PRE-BID ADDENDUM NO. 3

Project Bid: 2013 Parking Lot #2 Improvements

Date Issued: March 4, 2013

ANTICIPATED REMOVALS
 BEFORE SCHEDULED REMOVALS
 OF PAVT & SIDEWALK

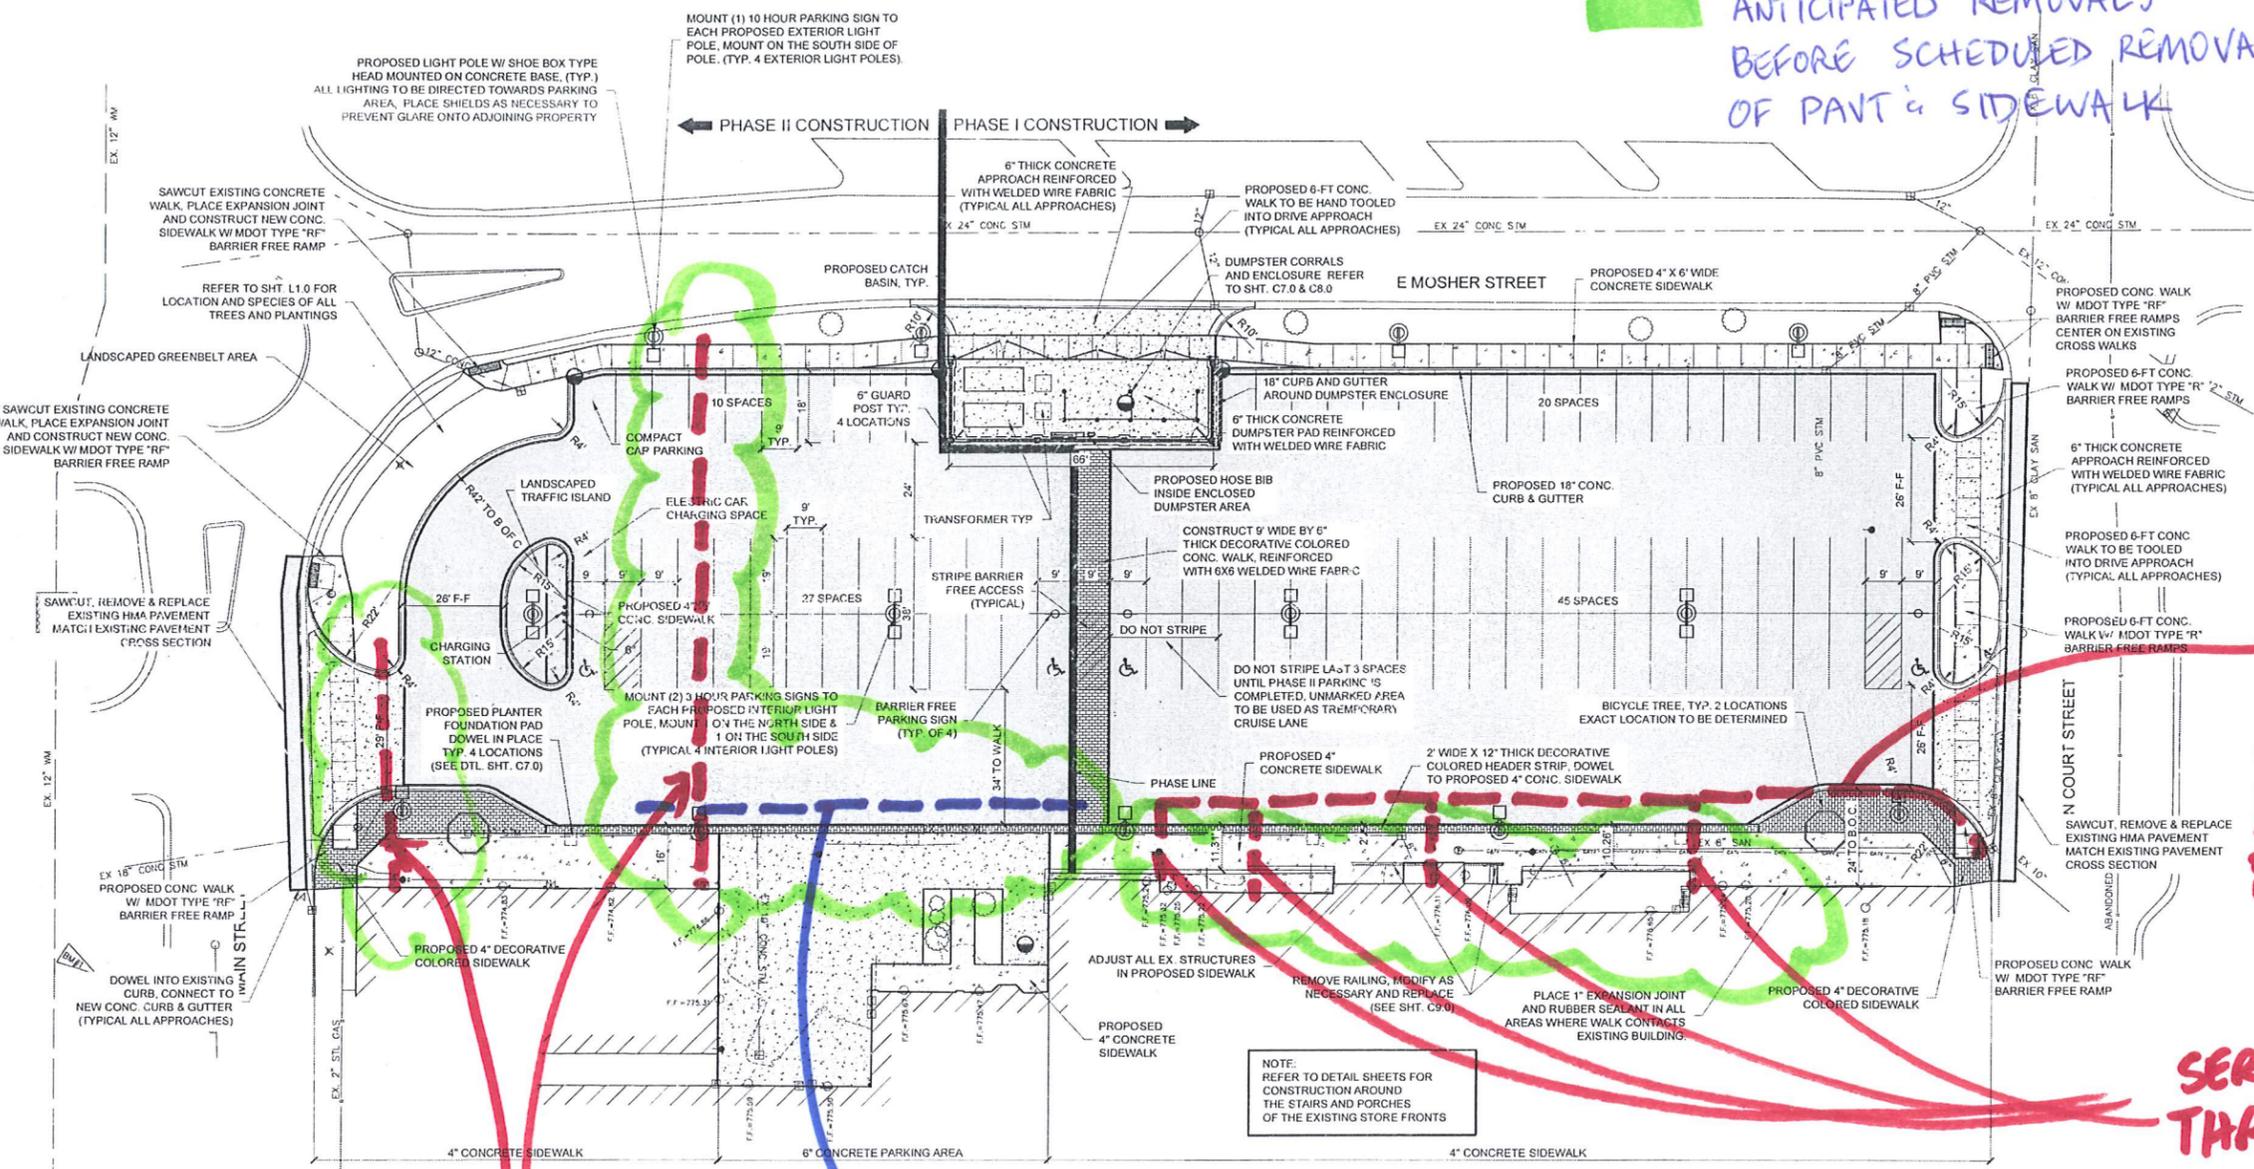
11. **Pavement Removal for Utility Company Work: We have no direction as to where these utility trenches are located to bid the appropriate saw cutting and removal. With the depth of the existing pavement section the saw cutting costs will be significant. See the attached sketch for anticipated removal required for Utility Company Work. Quantities on the Proposal Form has been revised.**
12. **Milling is to be performed in each phase of the work. The entire parking lot will not be milled at one time.**
13. **Pay item units for Pavt Mrkg, Waterborne, 4 inch, _____ have been changed to LF per the revised Proposal Form attached.**
14. **A QO load center may be used in lieu of the NQ load center.**

-- CMS
 -- PHONE & CABLE

MAIN FEED
 UNDER
 EX. HMA
 & CONC.

SERVICES
 THROUGH
 SIDEWALK

UNDER
 EX. HMA
 & CONC.

MAIN FEED TO
 NEW TRANSFORMERS
